KINCOPPAL – ROSE BAY SCHOOL OF THE SACRED HEART NEW SOUTH HEAD ROAD, ROSE BAY SSD APPLICATION – REVISED

RESPONSE TO SUBMISSIONS

Figure 9 View from harbour – existing – V4

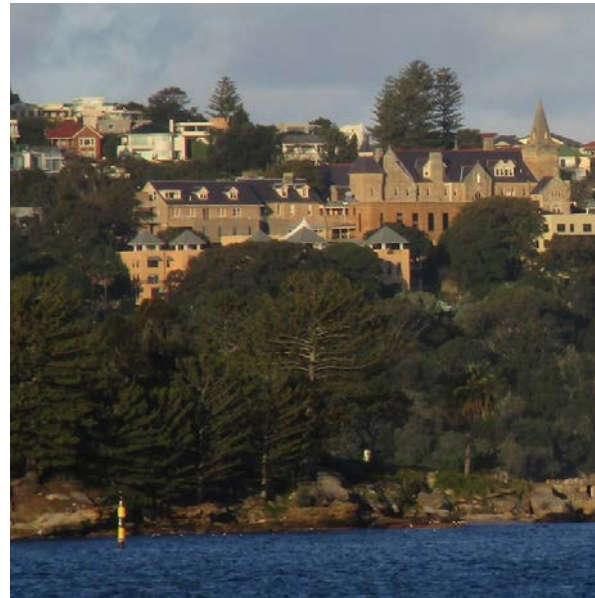
It is acknowledged that when viewed from the north-west, including from the Junior School and its grounds, the existing Claremont Villa will be substantially masked by the proposal. However, it is already substantially obscured by existing buildings, particularly the 1958 addition, immediately to its north. As one progresses further west, this view opens up. Note Claremont Villa includes the 2 right-hand dormers. The 3 dormers to the left (2 gabled and one flat) are on the large addition built in 1958.

The Year 8 Centre has been designed to step back from the south, specifically to minimise intrusion into these changing views while retaining a formal relationship with the gabled language of Claremont Villa and the 1958 addition.

It is our opinion that the design of the proposed Year 8 Centre will have some impact on views from the north-west, but as these are more oblique and changing views, they are not as significant as those to the west, where the important longer and closer views will not be affected.
